REMARKS/ARGUMENTS

Amendments to the Drawings:

FIG.5

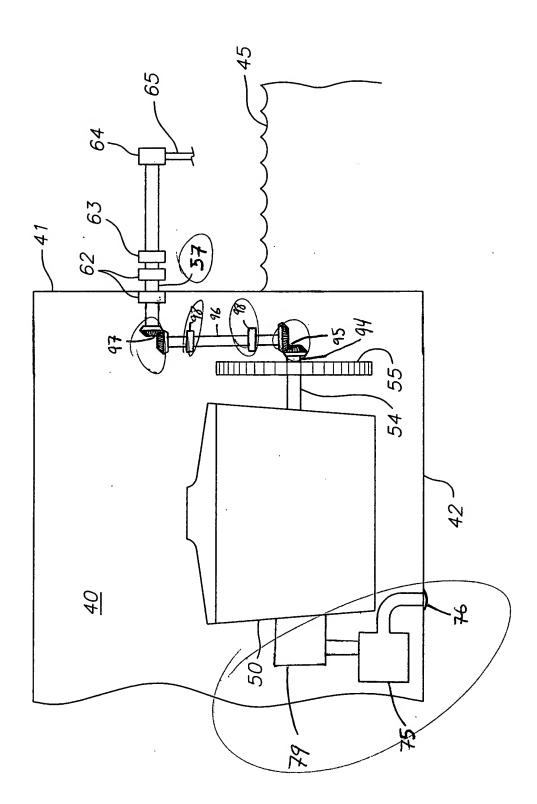
The Examiner has objected to the Drawings under 37 CFR 1.83(a), noting that the drawings must show every feature of the invention specified in the claims. Accordingly, Applicant has amended Fig. 5 to more clearly show the upper gear set 97 and lower gear set 95 as bevel gears. Support for these bevel gears may be found in the paragraph in the specification beginning on page 7, line 15.

Fig. 5 also now shows a water pump 75, water intake 76 and a cooling system 79 connected to the engine 50. Page 15, line 3 of the specification has been likewise amended to denote these elements in the context of Fig. 5. Support for these amendments to the Fig. 5 and the specification may be found on page 7, line 24, which recites:

In addition, Applicant has now added the two bearings 98 to Fig. 5, these having been inadvertently omitted from the previous Fig. 5 and support for which may be found on page 14, line 22, as well as having corrected notation for the upper driveshaft 57, which was inadvertently labeled "52" in the previous Fig. 5.
